WATER PERMIT NO. 8547-3

**SOUTH DAKOTA
WATER PERMIT NO. 8547-3**

**RECOMMENDATION OF CHIEF ENGINEER FOR WATER PERMIT
APPLICATION NO. 8547-3, L & E Holdings LLC**

REPORT TO THE CHIEF ENGINEER
ON
WATER PERMIT APPLICATION NO. 8547-3
L & E HOLDINGS
C/O BRANDON L MADDOX
DECEMBER 2, 2021

Well
Location

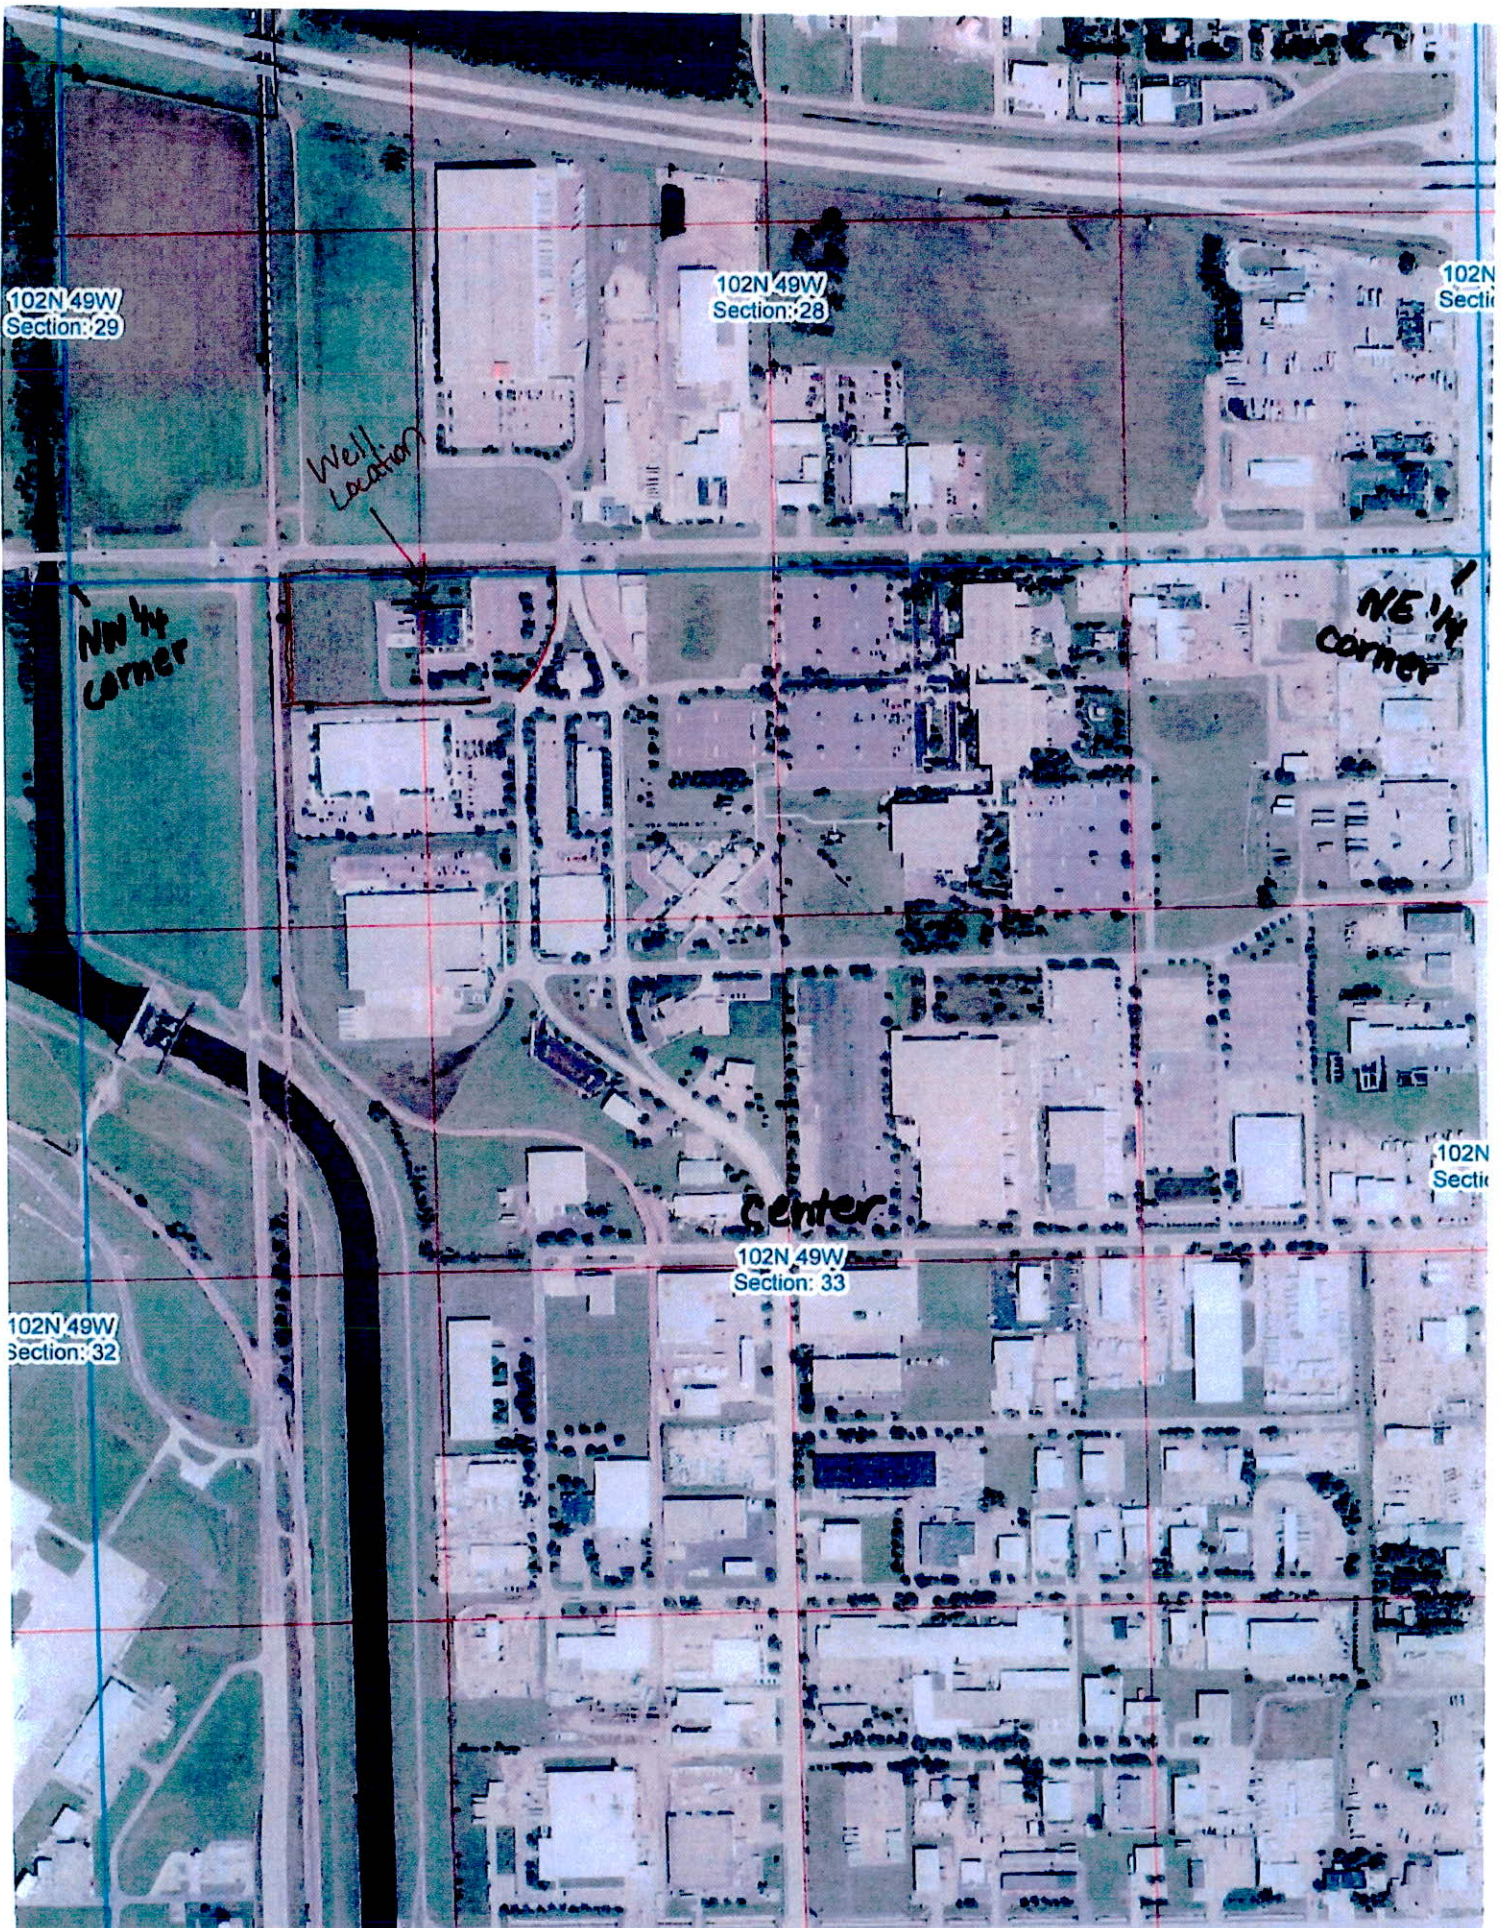
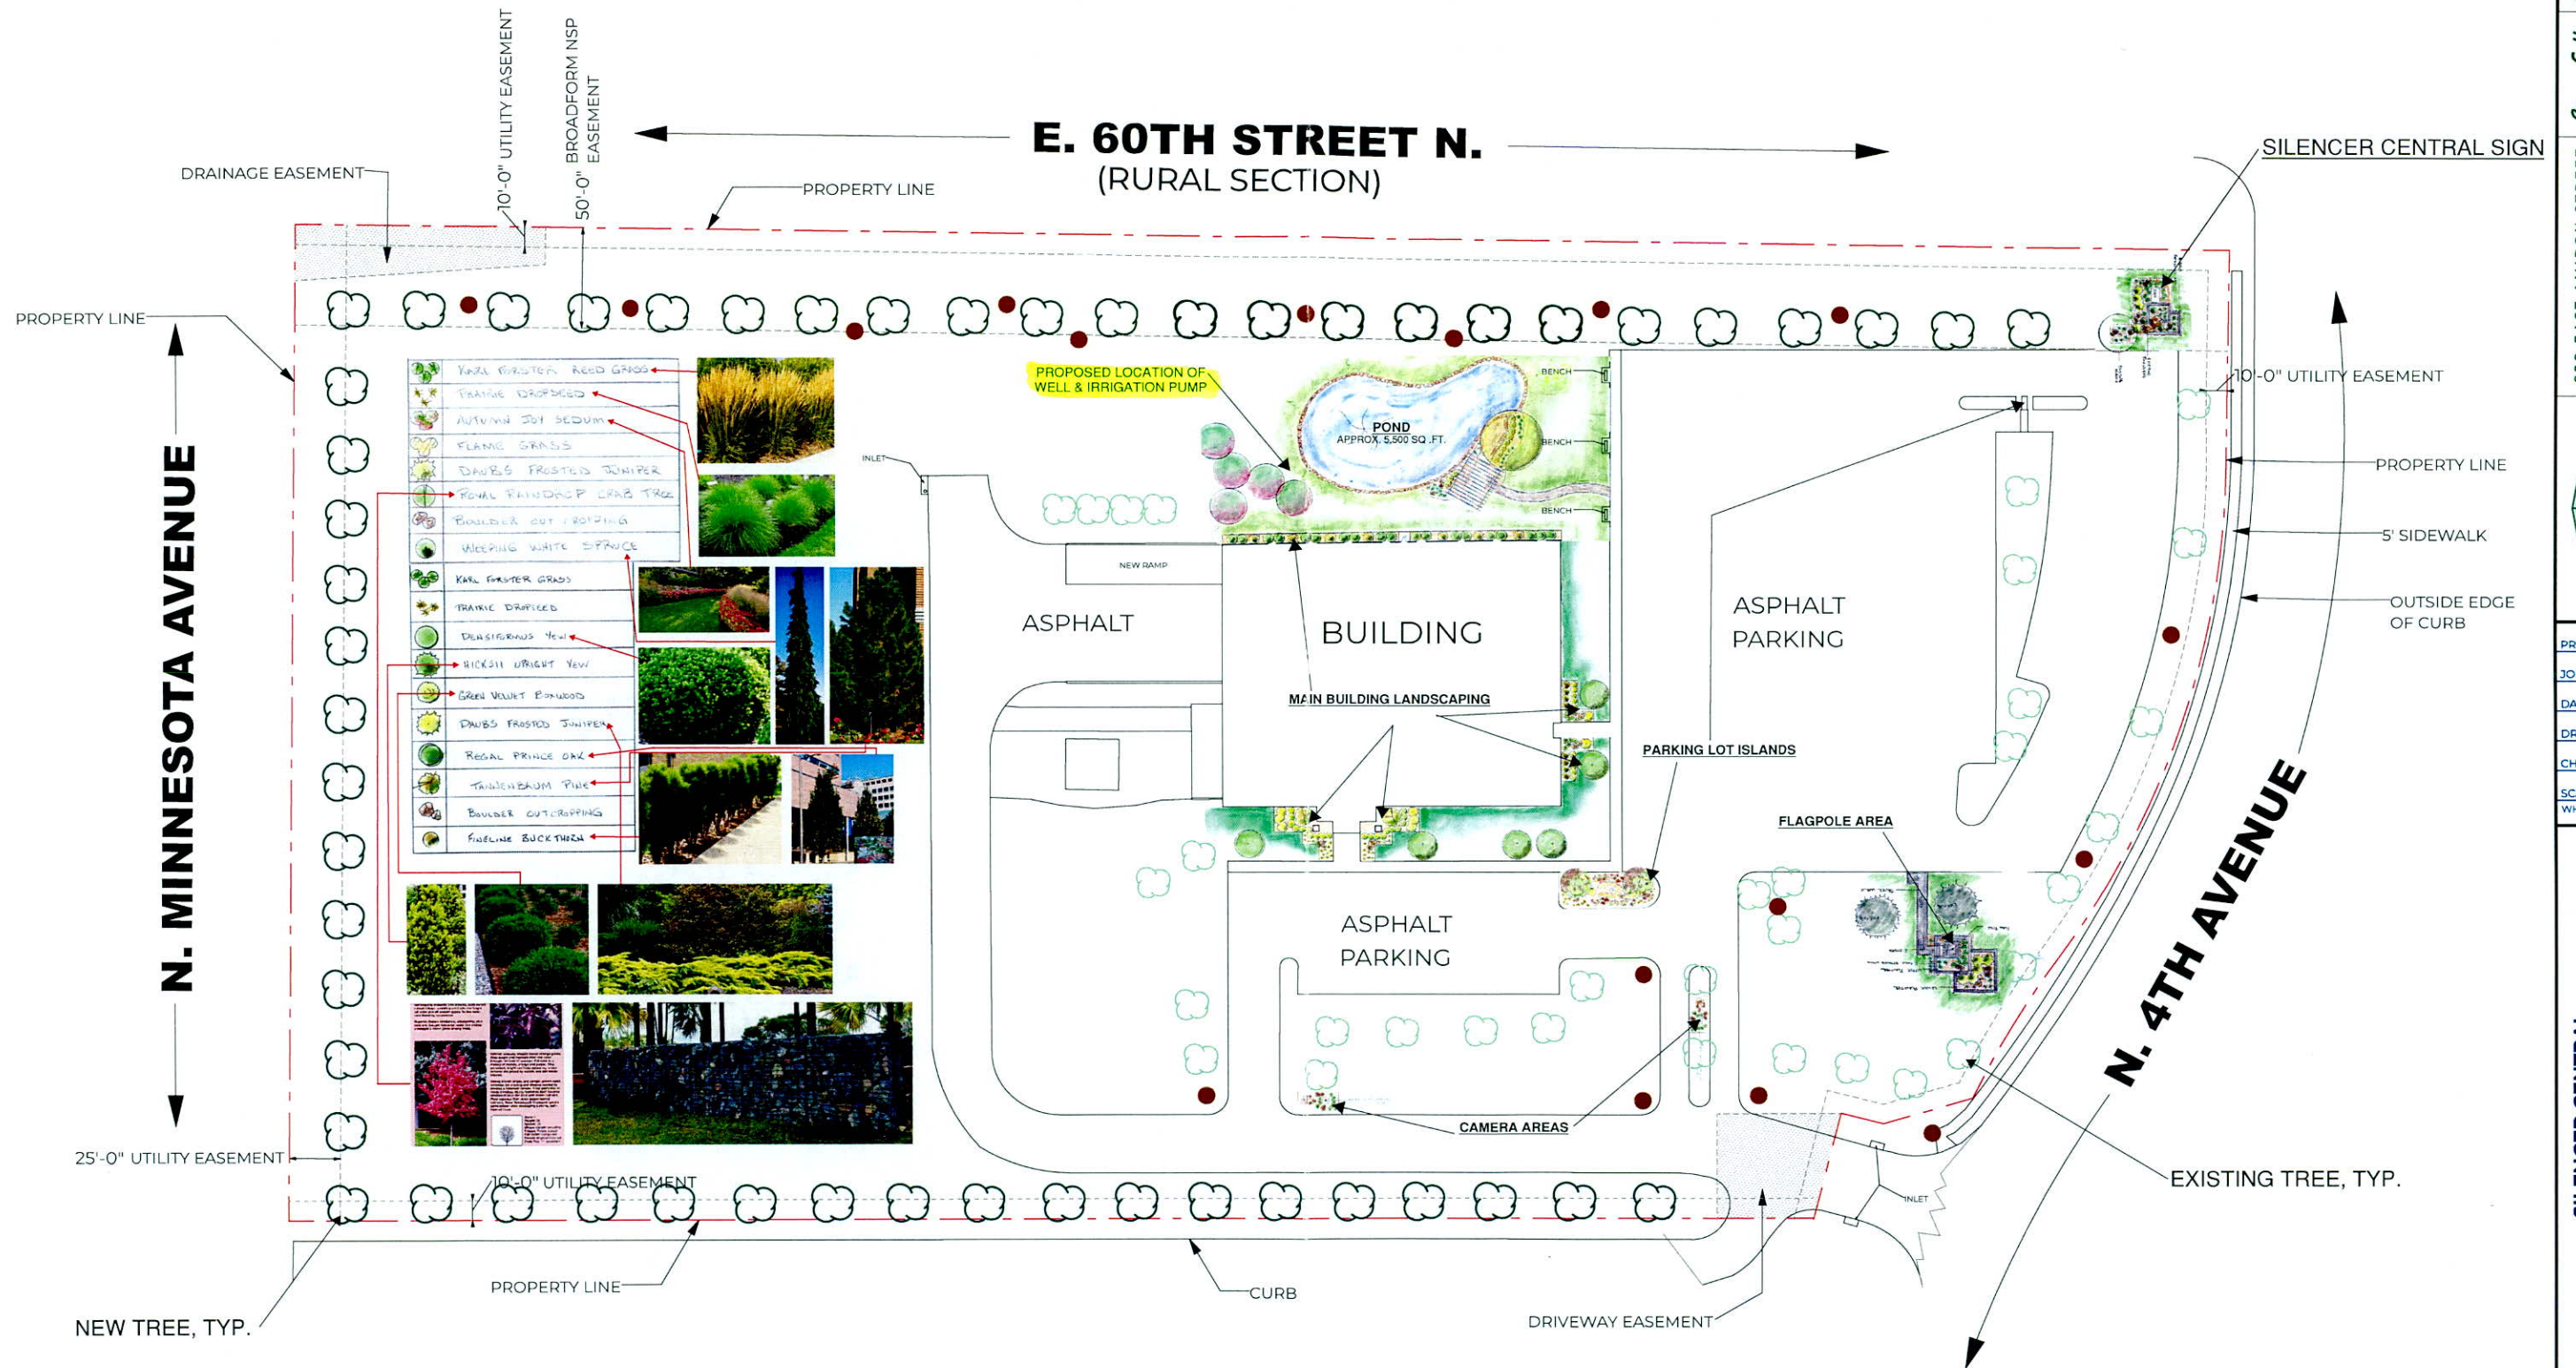
- A map needs to be submitted that references a government section corner or quarter corner including section, township and range. Please outline the acres to be irrigated and mark the proposed well location with an "X".

Please see the attachment for the maps that you requested. I have outlined the property that will be irrigated as well as an "x" showing the proposed well location. As discussed with you today, I believe the location you provided is correct. The lot size is 11.39 acres, but as I said before, that includes the building, parking lot, and sidewalks which will not be irrigated. Your response was as follows; *"Based on this map and comparing it with the maps submitted with the application, the proposed location of the well and pond will be the NE ¼ NW ¼ Section 33-T102N-R49W. The acres to be irrigated will be located within the N ½ NW ¼ Section 33-T102N-R49W. We will include Lot 6 Blk 4 Sioux Empire Development Park Two Addition with the above legal descriptions."*
